**Delco Carburetor**

**BULLETIN 9D-201**

## **SERVICE INFORMATION**

**SUBJECT:** New Screw Kit Released for Monojet Carburetors

**SUBJECT:** Quadrajets Secondary Main Well Seal

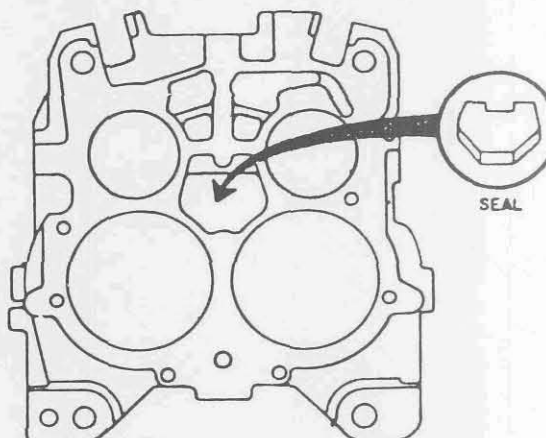
Some cases of fuel leakage at the secondary main well plugs have been reported on early model quadrajets.

If leakage occurs past the two plugs, it will fill the secondary well cavity in the throttle body with fuel. The fuel then seeps through the throttle body-to-bowl gasket, and into the carburetor bores which could result in rough idle or hard starting.

To stop this seepage of fuel, a special Viton\* seal is available for service use only. Use of this seal avoids the possibility of cracking the bowl when installing some types of plugs available on the market.

1. Remove carburetor from engine.
2. Disconnect accelerator pump rod.
3. Remove float bowl-to-throttle body attaching screws and two long air horn attaching screws at rear of carburetor and remove throttle body.
4. Insert seal, part #7041342, into bottom of secondary well cavity in throttle body, see figure below.
5. Replace throttle body to float bowl, tightening attaching screws and two air horn screws evenly and securely.
6. Reconnect accelerator pump rod and install carburetor on engine.

**SUBJECT:** MONOJET CARBURETOR CHOKE SHAFT  
AND LEVER REPLACEMENT

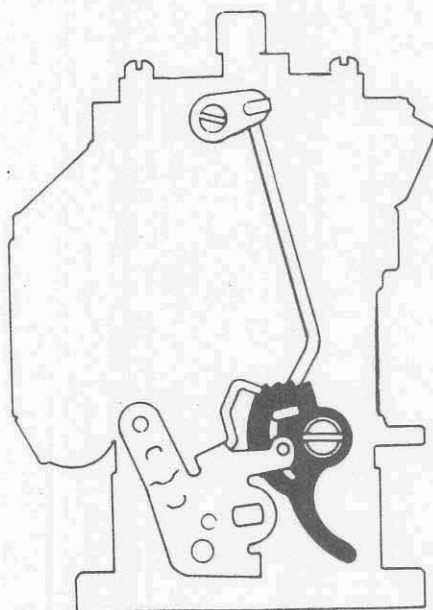
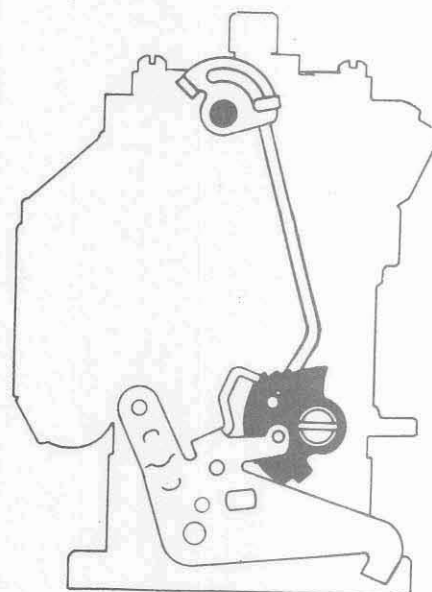
All 1968 Monojet carburetors have a slot in the fast idle cam to allow free movement of the choke rod in the cam. The upper choke rod lever has a standard hole for attachment of the upper end of the choke rod to the choke shaft.

On 1969 and later models the upper choke lever is slotted for free movement of the choke rod and the fast idle cam has a standard hole. On these models a choke shaft and lever kit, Part No. 7036973, must be used if necessary to replace the upper choke rod slotted lever or the choke shaft and coil lever assembly.

If choke shaft replacement is necessary, it should be serviced with choke shaft and lever assembly, Part No. 7034009. The upper choke rod lever is still serviced separately under Part Number 7034056.

The new kit, Part Number 7036973, contains a choke shaft with the slotted choke lever spun on one end and a separate choke coil rod lever with an attaching screw.

**SUBJECT:** Monojet Main Well Plug Kit

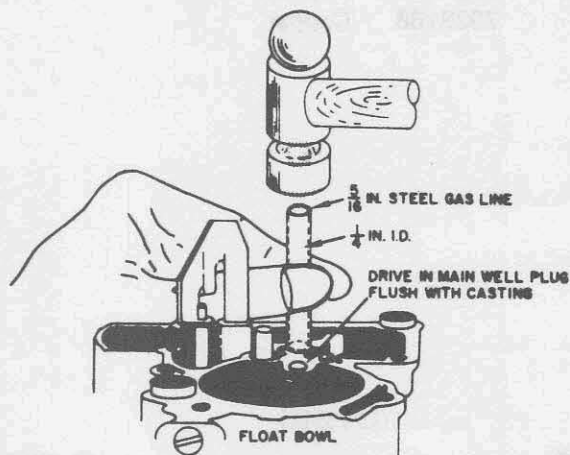
The main well plug is a press fit and is located in top of main well as shown. To install use a tool made from a piece of 5/16" steel gas line tubing cut to 3" length. The inside diameter of gas line is approximately 1/4". If a piece of regular tubing is used, make sure the inside diameter is the above dimension. Remove burrs from end of tube.

1. Remove carburetor from engine; then remove air horn assembly from float bowl.
2. Start new main well plug into top of main well with fingers. Make sure sides of plug are vertical with hole in main well.
3. Using the 3" piece of 5/16" steel gas line and hammer, carefully drive main well plug inward until bead on plug rests on top of main well casting. SEE DRAWING.

**CAUTION:** Do not use any type sealer on main well plug as it may get into fuel channels.

HOOK CLIP OVER EDGE OF  
FLOAT ARM

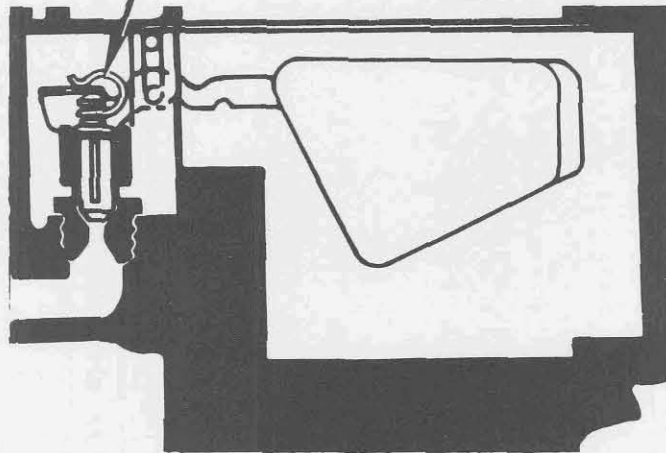
Reports have been received of incorrect installation of the float needle pull clip on the float arm during field replacement. If the clip is not installed as recommended, carburetor flooding can result.

It is reported that the end of the pull clip is being installed through the holes in the top of the float arm above the needle. These are locating holes used for manufacture of the float arm and are not to be used for the pull clip.

Correct installation of the float needle pull clip, is to hook the clip over the edge of the flat on float arm facing the float pontoon, as shown.

**SUBJECT:** PUMP ROD REMOVAL ON ROCHESTER  
QUADRAJET CARBURETORS

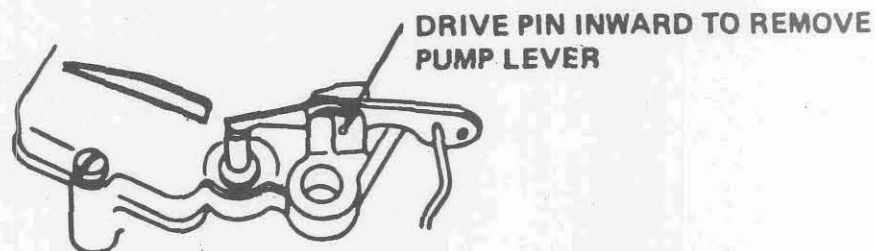
Reports have been received that the pump rod is being bent to remove the rod from upper pump lever when removing the air horn from float bowl. This is a bad safety practice as the pump rod will be weakened and also may cause a bind due to not being aligned properly after bending.

Correct removal of the pump rod should be done by driving the small roll pin retaining the upper pump lever inward (towards air cleaner boss) until the lever can be removed from boss on air horn. Then remove upper pump lever, pump rod and air horn assembly.

To install pump rod after air horn installation, install pump rod to throttle lever and upper end of rod to upper pump lever. Then insert upper lever into boss on air horn and push roll pin back through hole in pump lever until the outer end of pin is flush with boss on air horn. See sketch.

## **AIR VALVE SPRING ADJUSTMENT**

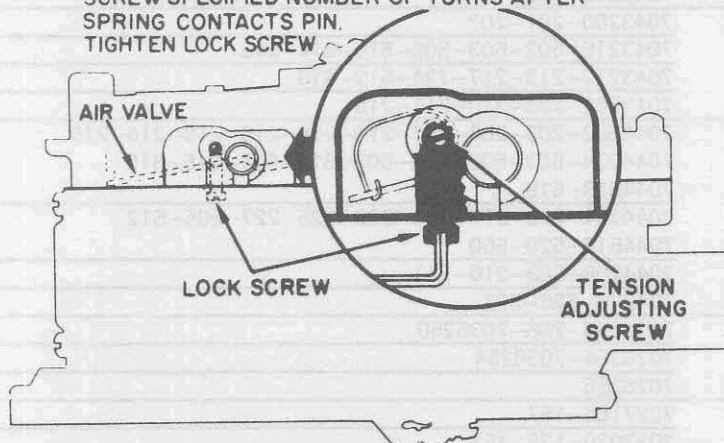
WITH LOCK SCREW LOOSENED AND  
WITH AIR VALVE CLOSED, TURN ADJUSTING  
SCREW SPECIFIED NUMBER OF TURNS AFTER  
SPRING CONTACTS PIN.  
TIGHTEN LOCK SCREW

**SUBJECT:** USE OF INCORRECT THROTTLE BODY TO  
FLOAT BOWL GASKET - QUADRAJET

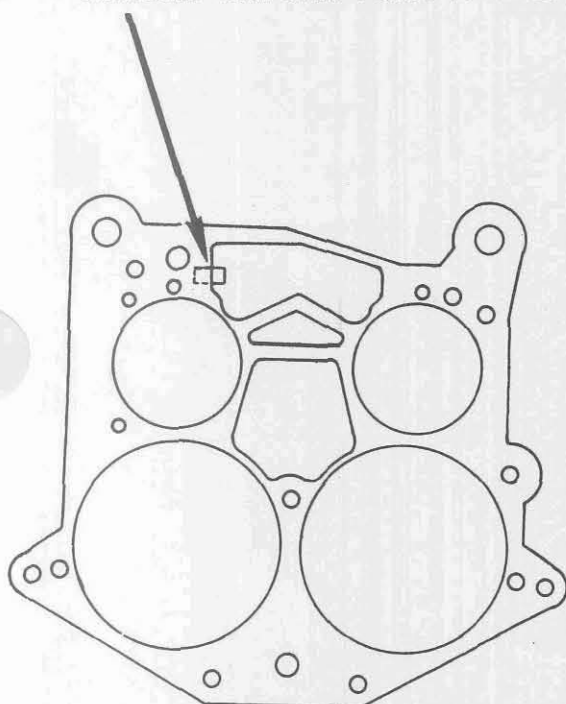
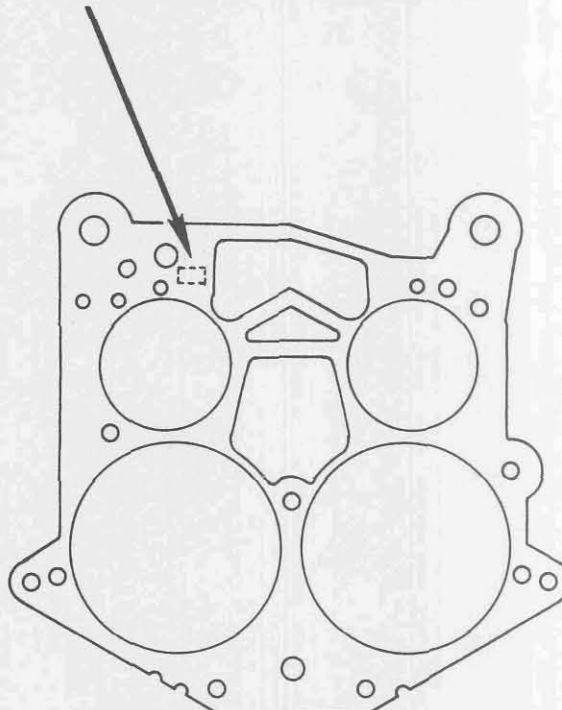
Field reports, along with returned samples, indicate servicemen sometimes are substituting the wrong throttle body to float bowl gasket on 1970 and later model Quadrajet carburetors. When this substitution is made, vacuum leaks occur causing rough idle due to air by-passing the primary throttle valves through the canister purge passage in the throttle body because the gasket will not seal this passage.

UNSEALED CANISTER PURGE PASSAGE

SEALED CANISTER PURGE PASSAGE

Therefore, in no case should the wrong throttle body to float bowl gasket be used on 1970 and later model Quadrajet carburetors.

**SUBJECT:** VAPOR CANISTER - PURGE VALVE REPAIR

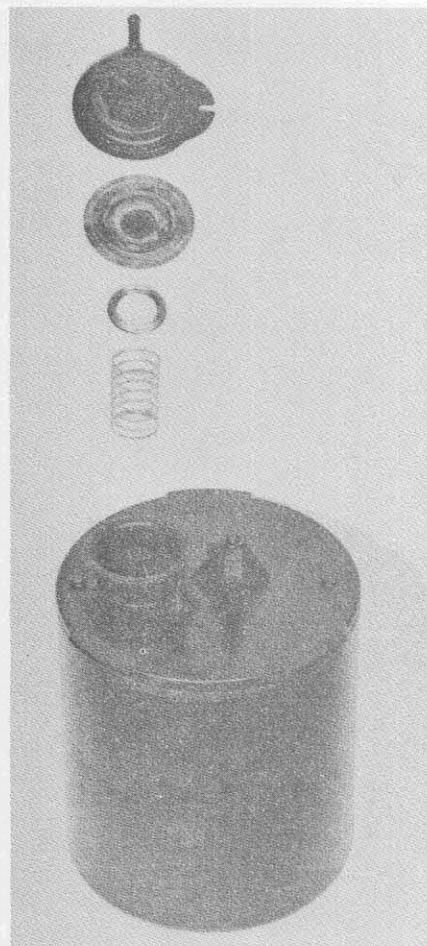
The purge valve located on the top of the fuel vapor collection canister, used on some applications, can be repaired without replacing the complete vapor canister. (See photo)

Install parts in order shown in photo. Make sure spring is seated in metal retainer and diaphragm lays flat between purge valve flange on canister and diaphragm cover. Snap diaphragm cover in place aligning vacuum pick-up tube with vacuum hose.

**SUBJECT:** REMOVAL OF CLIPLESS PUMP PLUNGER ASSEMBLY  
FROM INSIDE PUMP LEVER

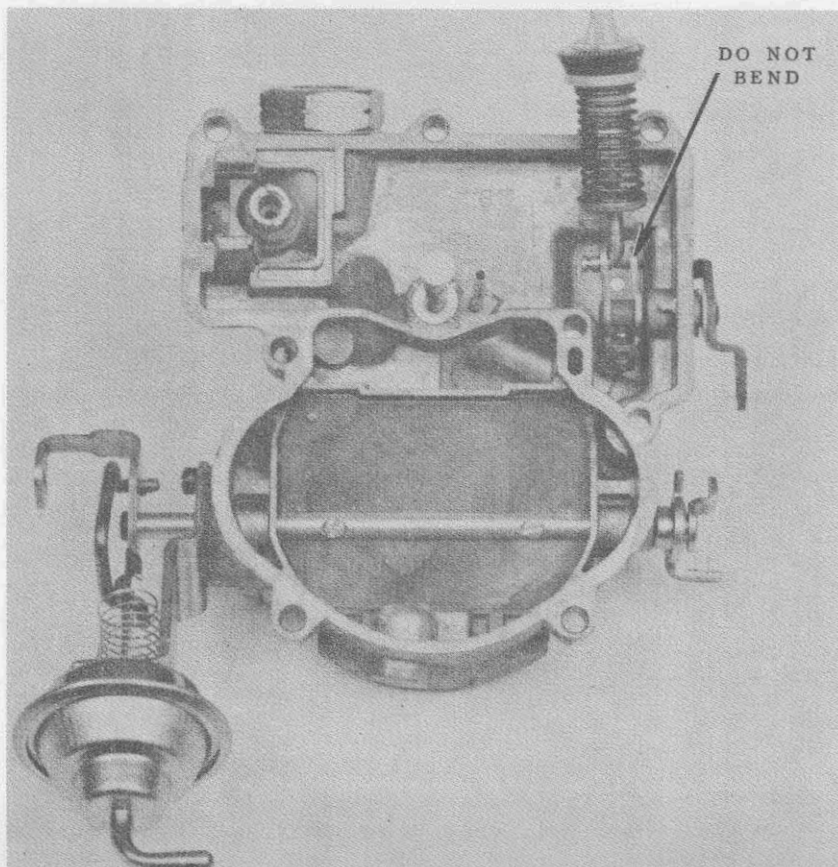
When removing the pump plunger assembly from the inner pump lever on those models not using a retaining clip, it is necessary to first remove the inner pump lever from the pump shaft by loosening set screw on inner lever. Then remove inner pump lever from pump shaft. Rotate pump plunger assembly until upper end of plunger rod slips out of hole in inner pump lever.

**CAUTION:** Do not remove pump plunger assembly by bending the retaining arm on inner lever. If bent, the retaining arm can cause binding, jamming and in some cases, allow the pump assembly to fall out of the lever.

**SUBJECT:** QUADRAJET CARBURETOR SECONDARY MAIN  
WELL SEAL

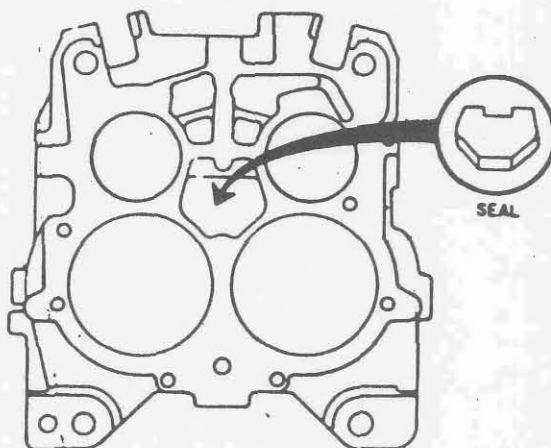
Field reports indicate servicemen are replacing the float bowl assembly and/or adding secondary main well plug seal 7041342 in the throttle body cavity (see illustration below), on Quadrajets carburetors that use the solid aluminum "spun-in" secondary main well plugs, to correct what appears to be "leaking secondary main well plugs". The presence of fuel in the cavity actually is due to "weeping action" whereby fuel from the secondary nozzles, during engine operation, seeps by the throttle body to bowl gasket to partially fill the cavity in the throttle body. Fuel in the throttle body cavity below the "spun-in" main well plugs will not affect operation and the float bowl assembly should not be replaced or the secondary main well plug seal 7041342 used.

If leakage of fuel at the secondary main well plugs is suspected, place the bowl on the bench on a dry, clean towel and fill the bowl with fuel. After about 5 minutes, carefully lift the bowl checking for dampness on the towel in the secondary main well plug location. If leakage is evident, the 7041342 seal may be installed in the throttle body cavity.

### INSTALLATION SECONDARY MAIN WELL PLUGS

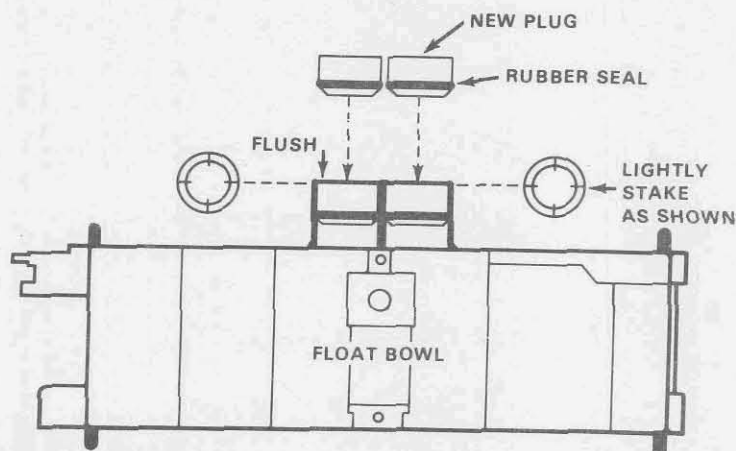
The secondary main well plug repair kit is released for use on early model carburetors which use the brass cup plug or solid aluminum plug without spinning. This kit should not be used on later models with the "spun-in" type secondary main well plug.

1. Disassemble carburetor.
2. Place float bowl on stand and fill half full of fuel.
3. Observe plug area for fuel seepage.
4. In plugs leak, remove early type brass cup plugs with "Easy-out". If plug is solid type (without spinning), use a 3/16" stop drill and drill hole 1/4" deep in center of old plug. Use "Easy-out" and remove plug.

CAUTION: Do not drill through plug as casting may be damaged in well area. Blow out casting to remove dirt and chips.

5. Install rubber "O" ring seal into groove in new plug. Lube assembly with light engine oil, then carefully drive plug into main well, chamfered end down. Top of plug should be flush with casting. Lightly stake in place.
